Comparison of the 2 Versions of SDF30A-THC

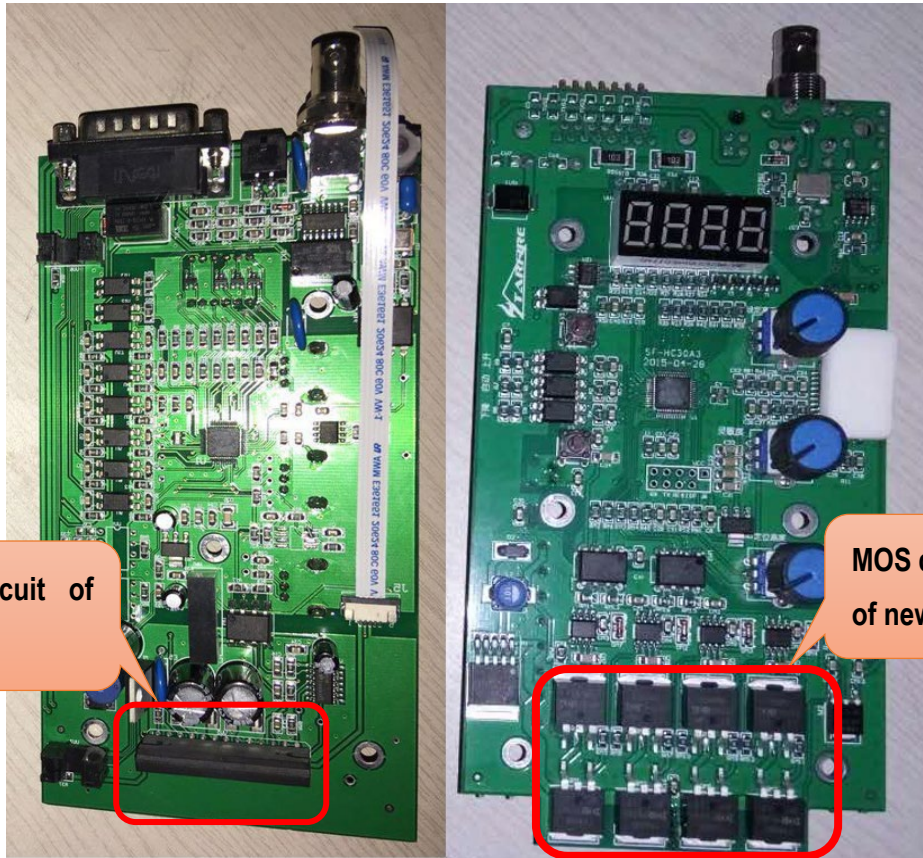
◆ 3.Convenience of Lift operating:

Two new buttons added on THC for going up or down.
